DEPARTMENT OF TRANSPORTATION

Federal Aviation Administration

[Docket No. 23340 Amendment Nos. 21-62, 25-63, and 36-15]

Standards Governing the Noise Certification of Aircraft

Table B2 — Tone Correction Factors

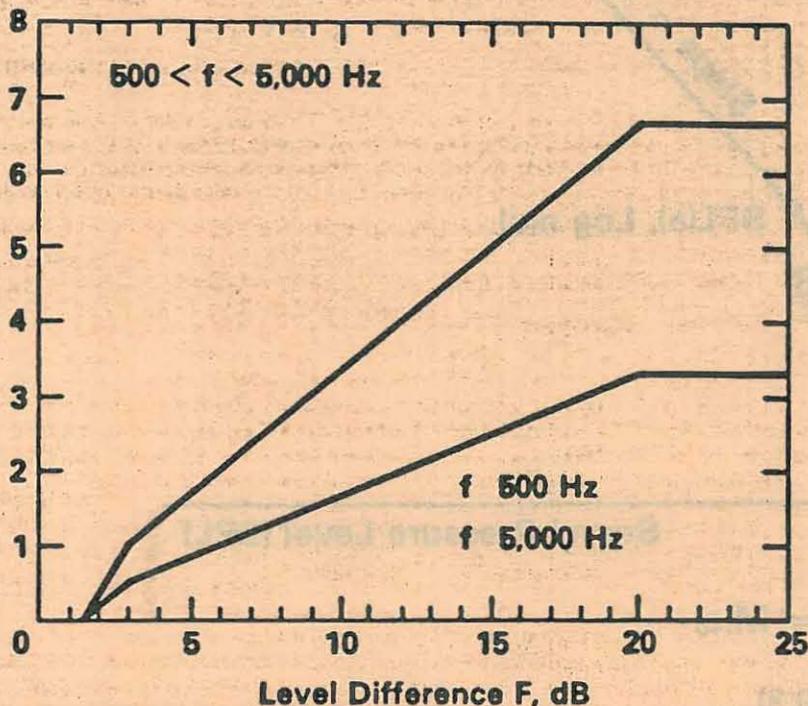
Section B36.5(h) and Table B-2 are revised to eliminate calculation of tone penalties for tones less than 1.5 decibels.

22. The graph and Table B2 now appearing in section B36.7(a) is moved into section B36.5(i) and revised to read as follows:

Frequency f, Hz	Level difference F, dB	Tone correction C, dB
50 < f < 500	1 1/2 * < F < 3	F/3 - 1/2
	3 < F < 20	F/6
	20 < F	3 1/2
500 < f < 5,000	1 1/2 * < F < 3	2 F/3 - 1
	3 < F < 20	F/3
	20 < F	6%
5,000 < f < 10,000	1 1/2 * < F < 3	F/3 - 1/2
	3 < F < 20	F/6
	20 < F	3 1/2

Fig. B3. Perceived Noisiness As a Function of Sound Pressure Level.

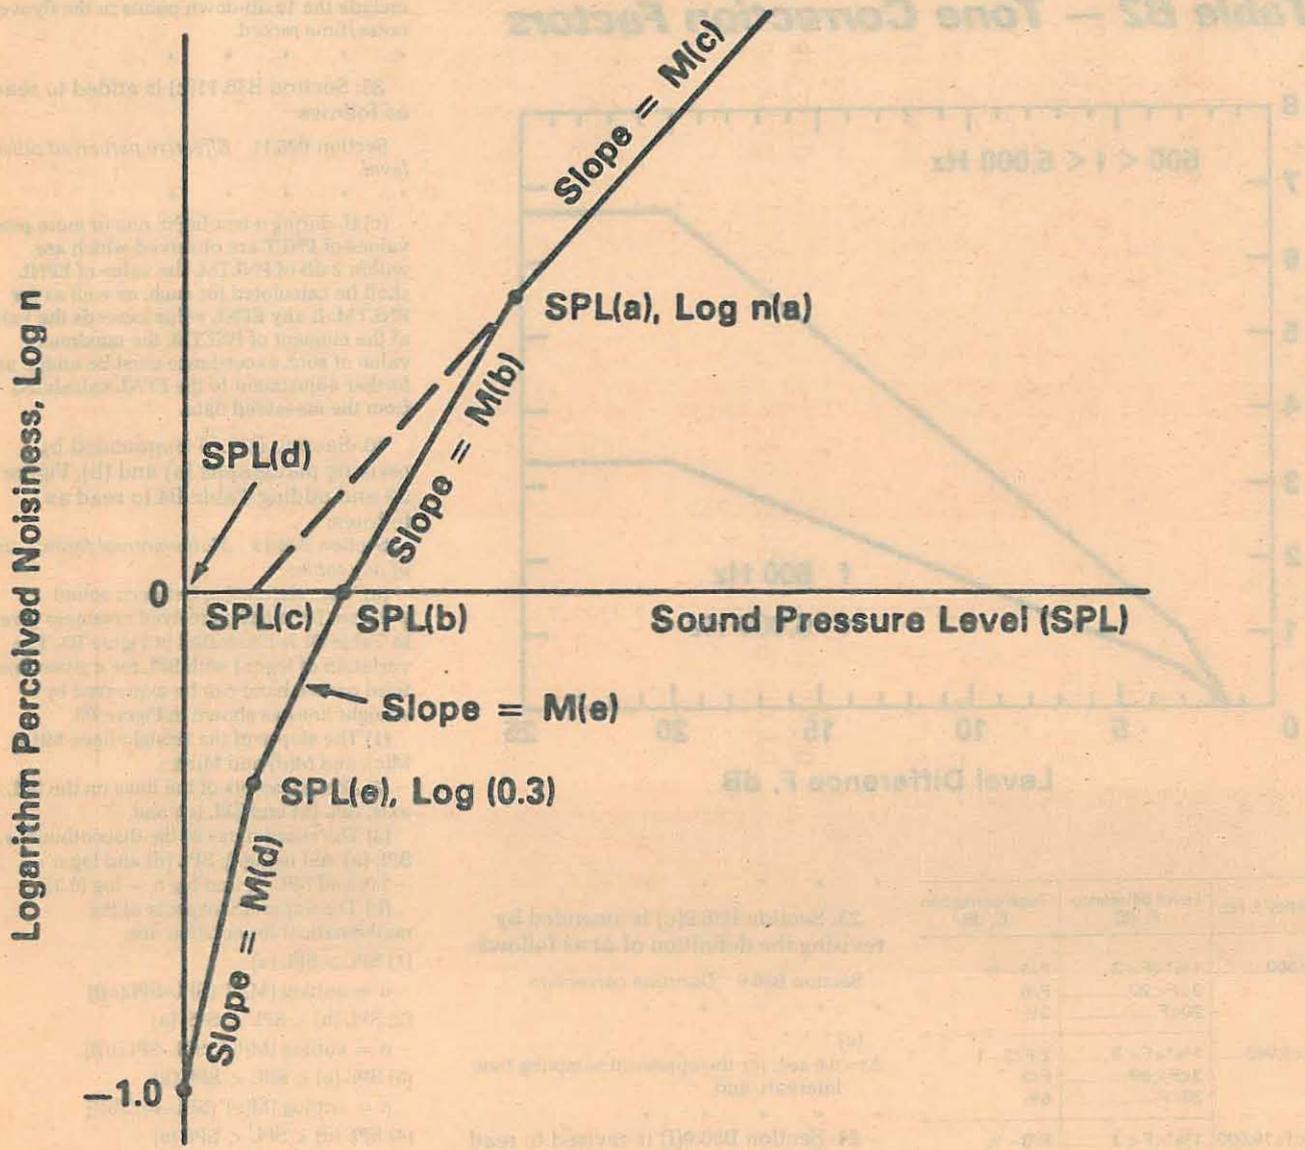
26. Section B36.13 is amended by revising paragraphs (a) and (b), Figure B3 and adding Table B4 to read as follows:

(a) The relationship between sound pressure level and perceived noisiness given in Table B1 is illustrated in Figure B3. The variation of $\log(n)$ with SPL for a given one-third octave band can be expressed by straight lines as shown in Figure B3.
